<b>DOCKETED</b>	
<b>Docket Number:</b>	23-OPT-01
<b>Project Title:</b>	Fountain Wind Project
<b>TN #:</b>	248330-4
<b>Document Title:</b>	Project Revisions Memo Feb 2021
<b>Description:</b>	N/A
<b>Filer:</b>	Caitlin Barns
<b>Organization:</b>	Stantec Consulting Services, Inc.
<b>Submitter Role:</b>	Applicant Consultant
<b>Submission Date:</b>	1/5/2023 10:09:40 AM
<b>Docketed Date:</b>	1/5/2023

To:	Lio Salazar	From:	Caitlin Barns
	Shasta County Planning		Portland, Oregon
File:	Fountain Wind Project	Date:	February 12, 2021

**Reference: Analyses of Refinements to the Project Description Since Circulation of the Draft Environmental Impact Report**

- Legend**
- Turbine
  - MET
  - Fiber Run
  - Permanent Disturbance Footprint
  - Permanent Disturbance
  - Temporary Disturbance

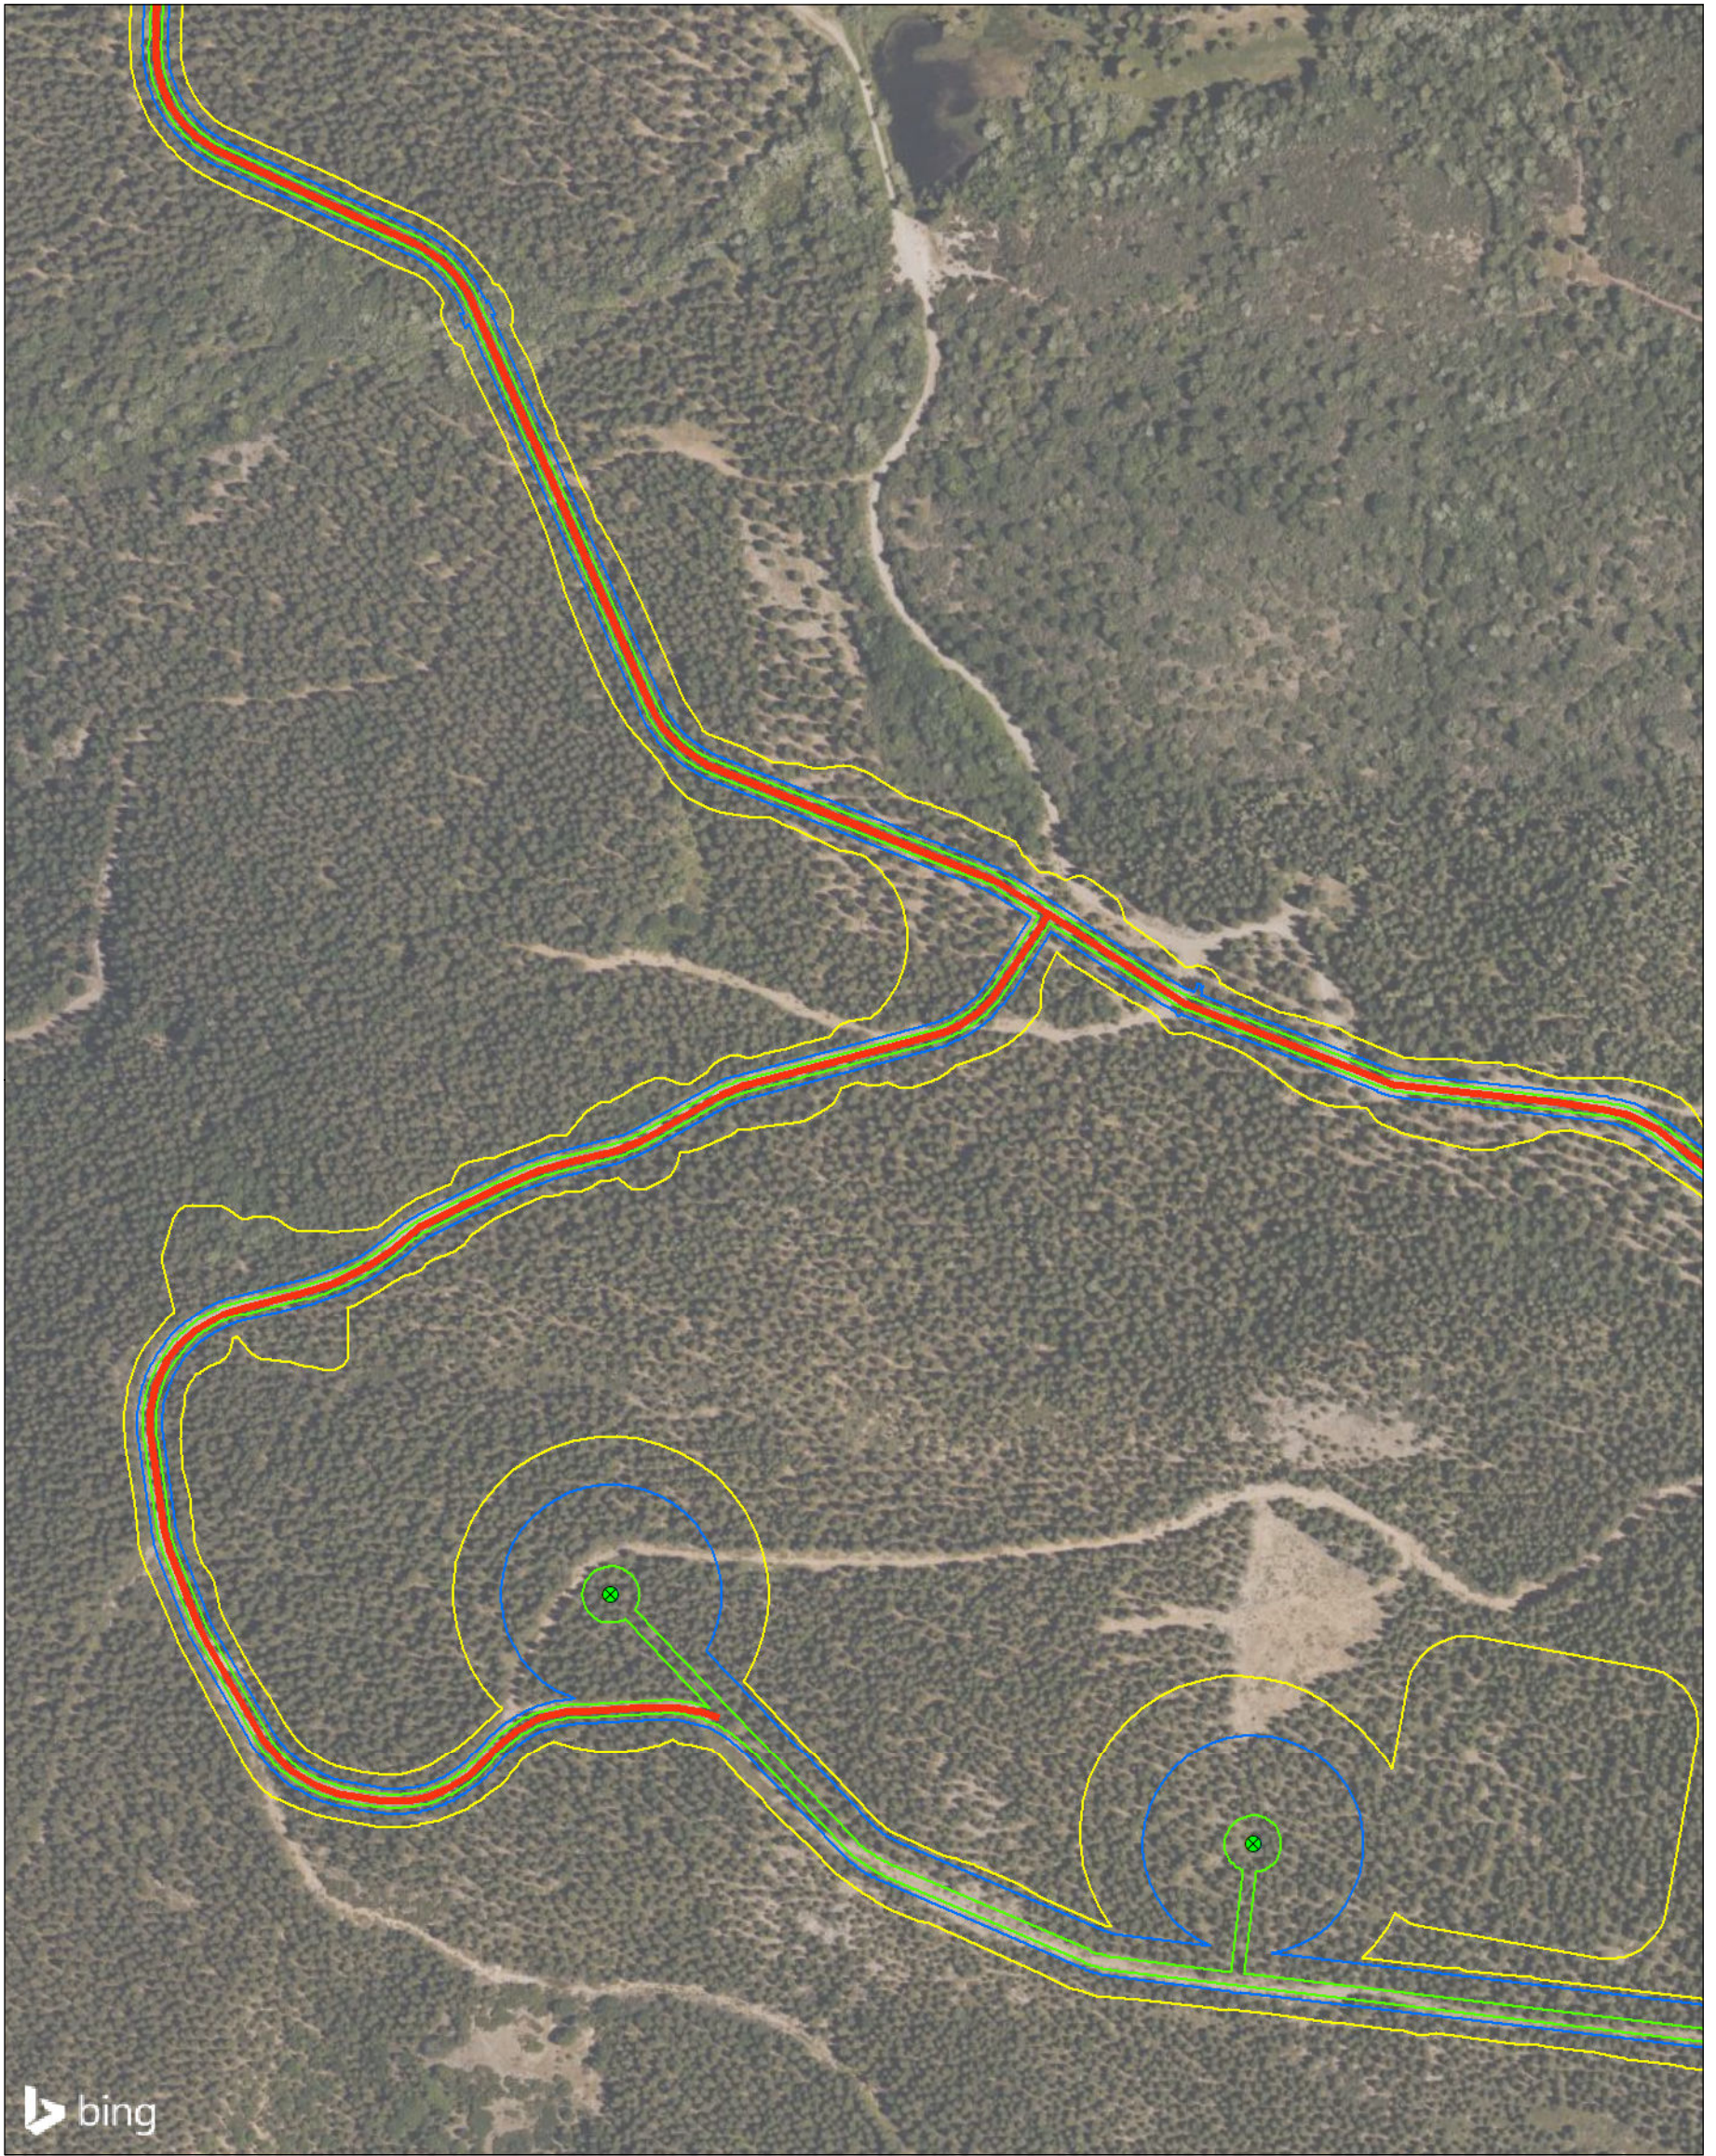
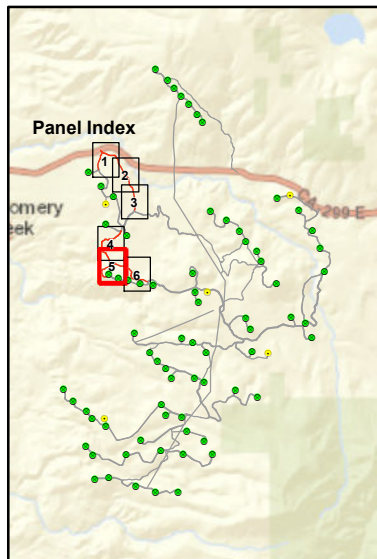
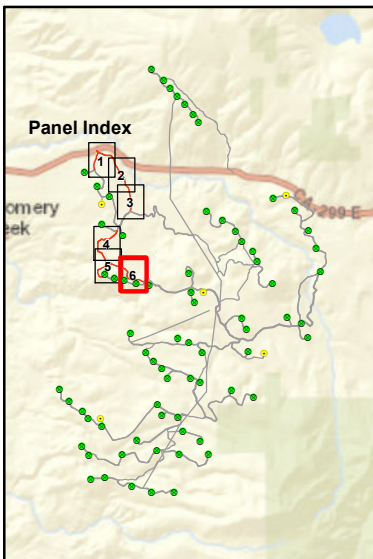
- **Clarification regarding fiber optic cable installation.** Chapter 2, Description of Project and Alternatives, in the Draft EIR states that the Project would include installation of a communication system within the same footprint as the electrical collection system. “The communication system consists of fiber optic communication cabling for the Supervisory Control and Data Acquisition (SCADA) system, which provides communication capabilities between turbine locations, substation, and operations and maintenance facilities. Most of the collector system would be located underground and adjacent to onsite access roads” (DEIR Section 2.4.2). To clarify this description, fiber optic cabling would be installed within the footprint of the electrical collection system as well as within approximately 4.5 miles of existing access roads in the northeastern portion of the Project Site. The approximately 4.5 miles of fiber optic cabling co-located with the existing roads would connect the proposed electrical system to the operations and maintenance facility, and to the existing fiber optic system located off of SR 299. See Figure 2.

Figure 3. Switchyard and Substation Design

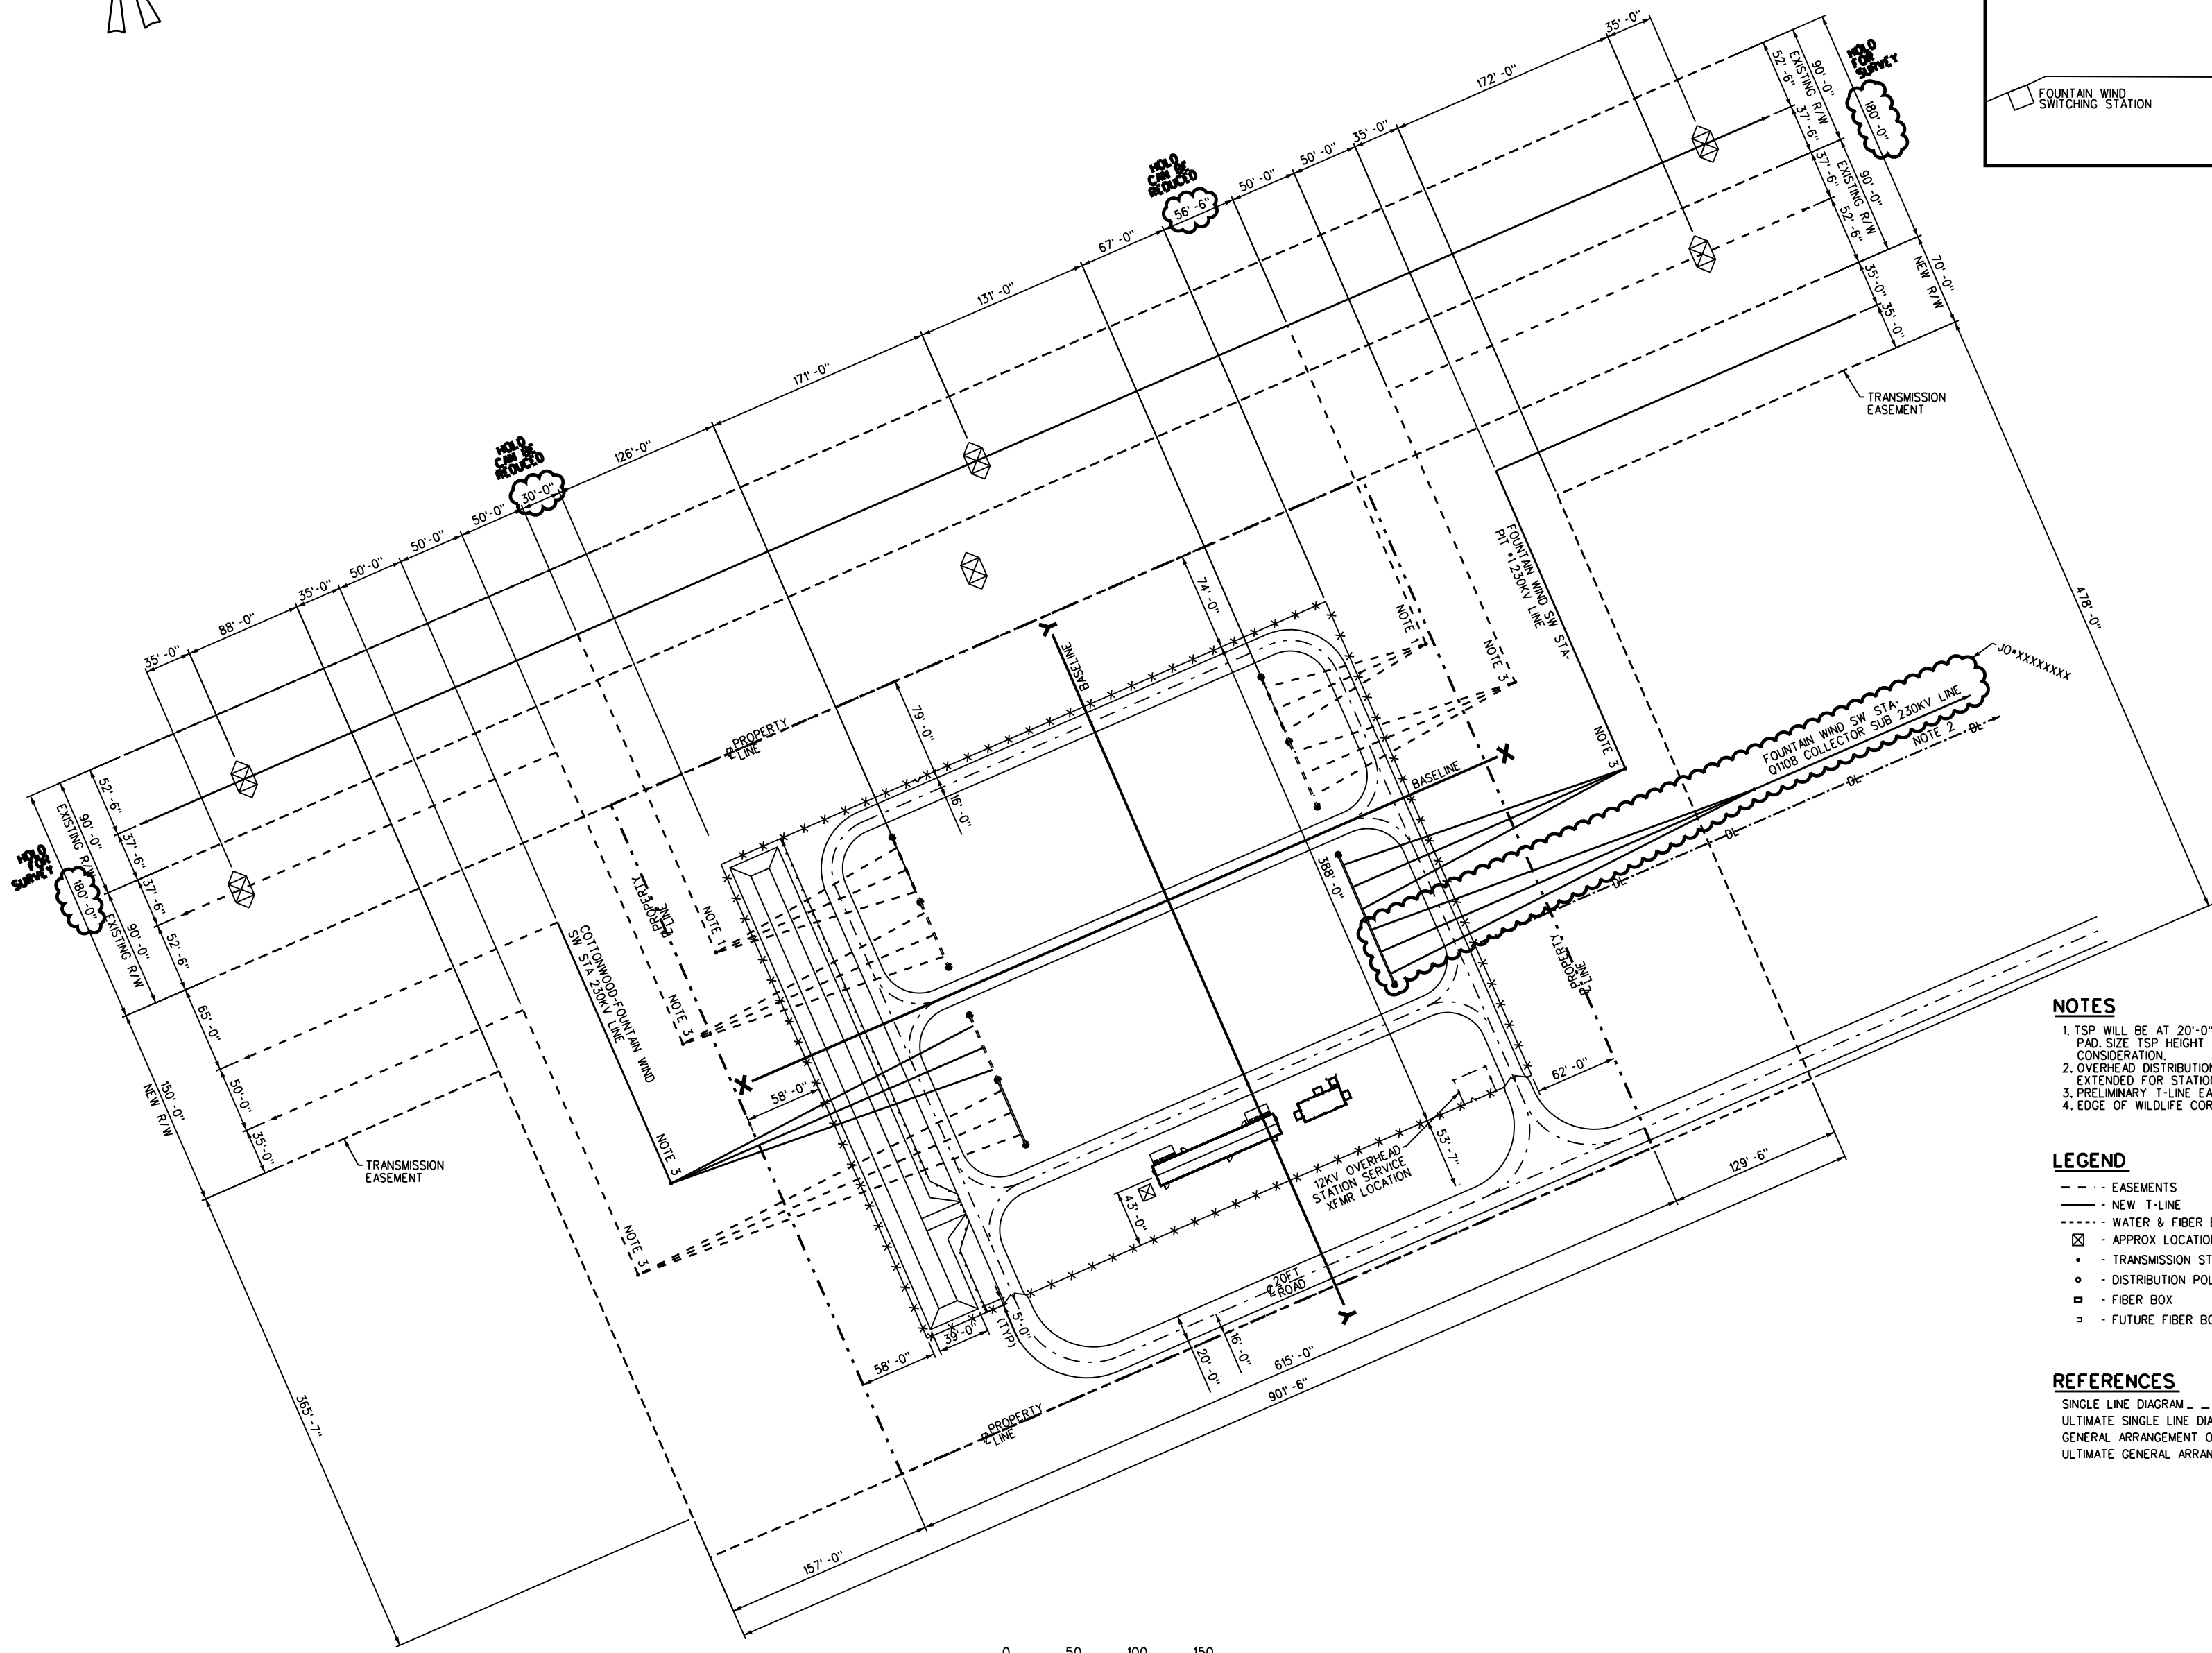
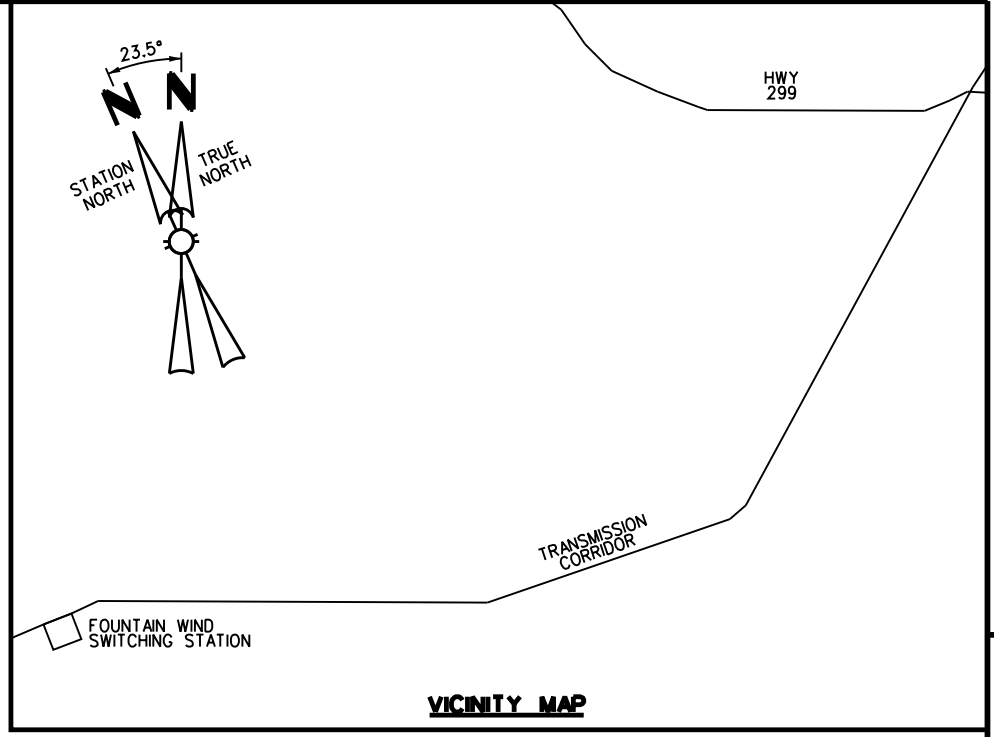
- **Clarification of PG&E facilities.** Chapter 2, Description of Project and Alternatives, in the Draft EIR describes the PG&E upgrades needed as a result of constructing the new substation and switching station:

“Upgrades to PG&E facilities are anticipated to include construction or reconfiguration of utility line structures and transmission line circuits involving four to six new transmission poles. If required, the new poles would be located adjacent to the proposed substation and switching station...The Applicant would construct the switching station; PG&E would construct the electrical connections to its facility. PG&E ultimately would own and operate the switching station and interconnection components” (DEIR Section 2.4.2).

Several clarifications are suggested for this description. First, in addition to the four to six new transmission poles, up to four replacement poles could be associated with replacement or reconfiguration of the existing utility line structures within the existing right of way. Second, a stormwater retention basin is planned for the proposed switching station facility and would be constructed within the switching station permanent footprint. See Figure 3 below which provides an updated design of the proposed switching station. Third, the switching station would be electrically connected to the substation. And lastly, the Applicant will build and own the Project substation while PG&E will own and operate the switching station and interconnection lines.
